TITLE:		FEATURE: Tannoy TS8 EQ LIMITER	
DRAWN:		INDIGO	
CHECKED:		INDIGO Manufacturing Inc.	
MODIFIED:		165 Steeple Road East	
RELEASED:		Markham, ON, L3R 1G1	
DATE:		REV:	
DATE:		C	
DATE:		SHEET: 1 OF 2

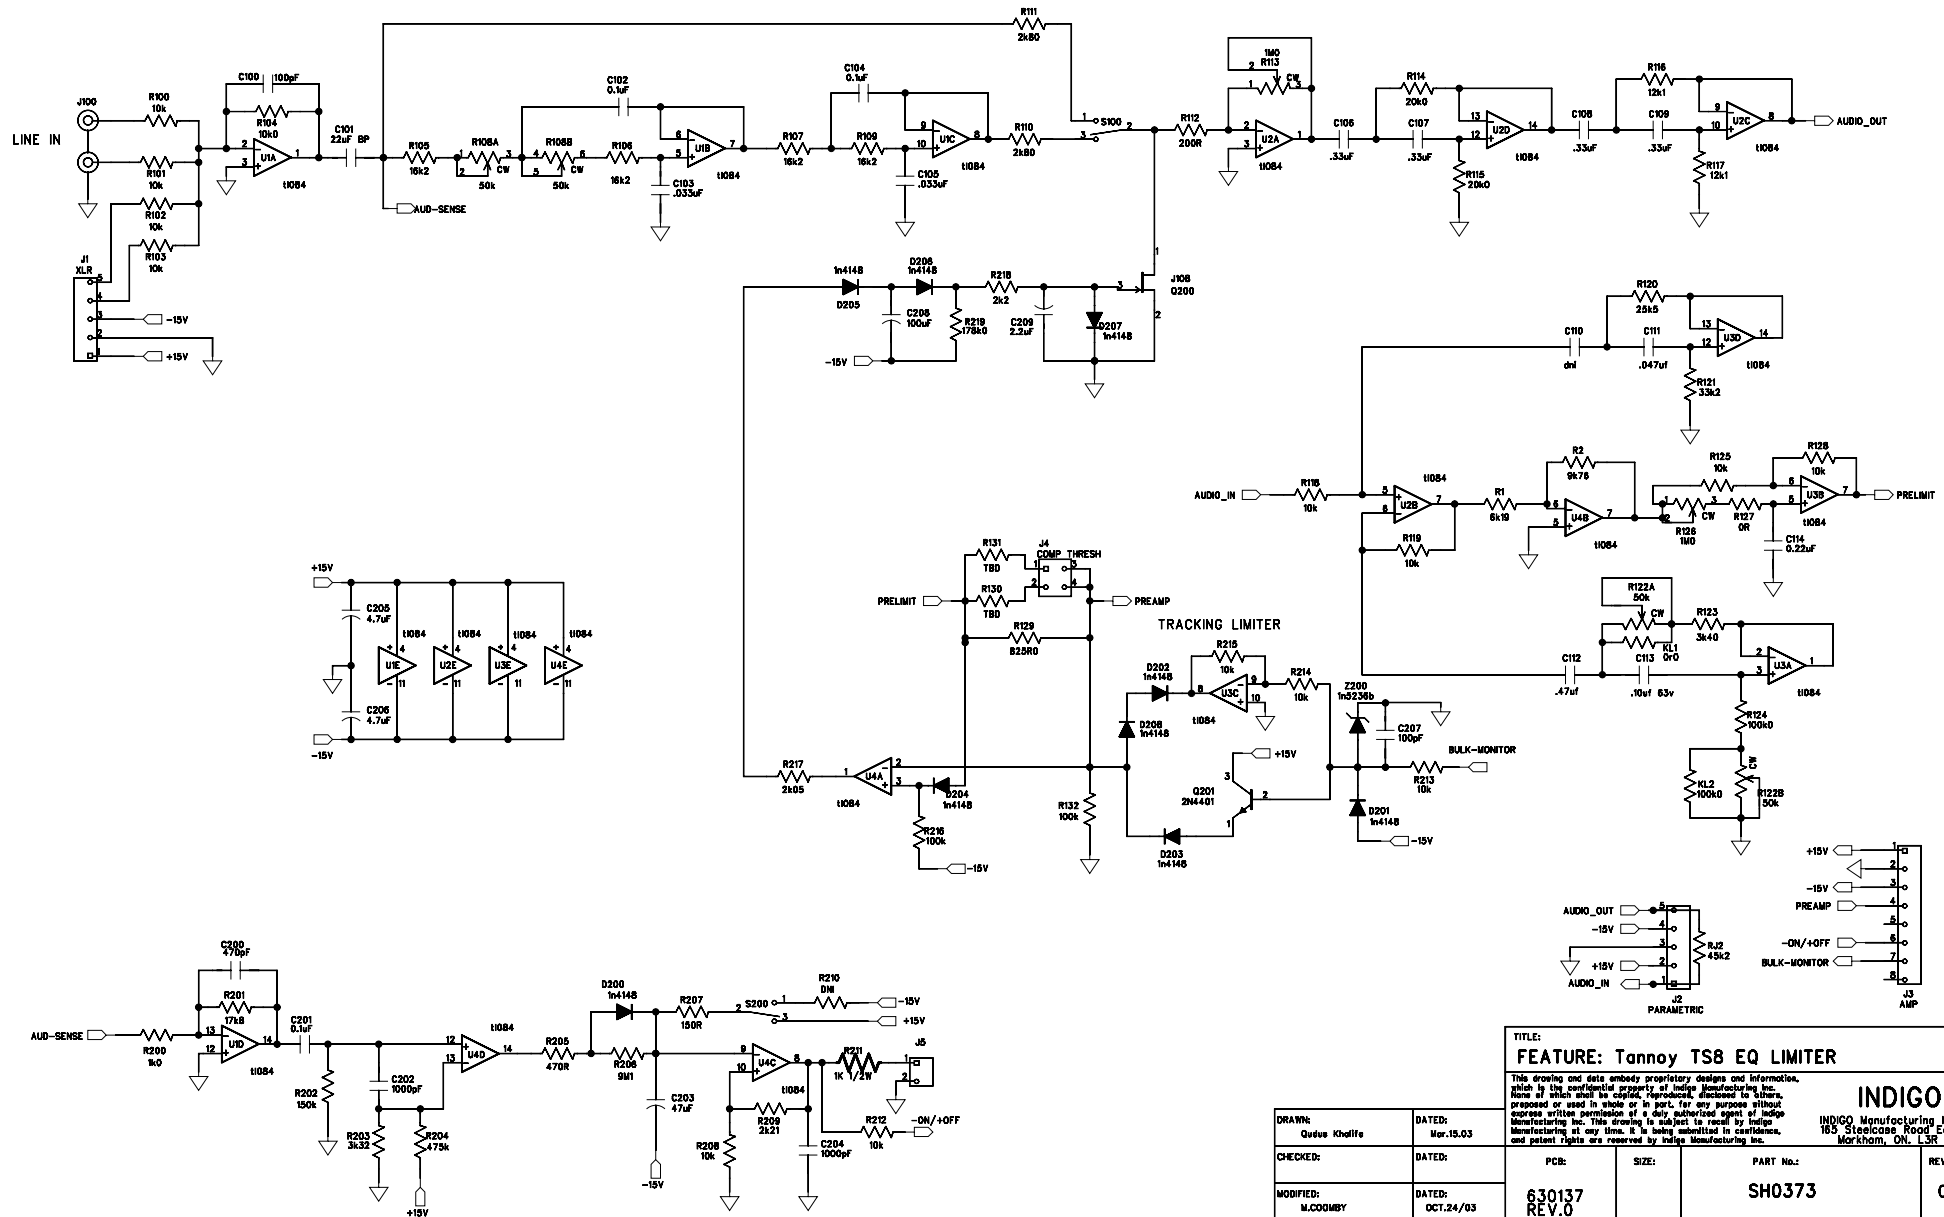
6				5				4				3				2				1			
Rev.	Date	ECR No.	APPROVED	DESCRIPTION				Rev.	Date	ECR No.	APPROVED	DESCRIPTION											
A	Mar.15.03		Qodus	Initial capture																			
B	OCT 24 03		M. Coomby	CONVERTED FROM 8CE TO 8CB CHANGED: R217 TO 2K05 pcb changed from 630137-a to 631137-0 R219 TO 178K0 R129 TO 825R0 R1 TO 6K19																			
B	NOV.6.03		M. Coomby	R113 FROM 1MEG TO 100K																			
		</
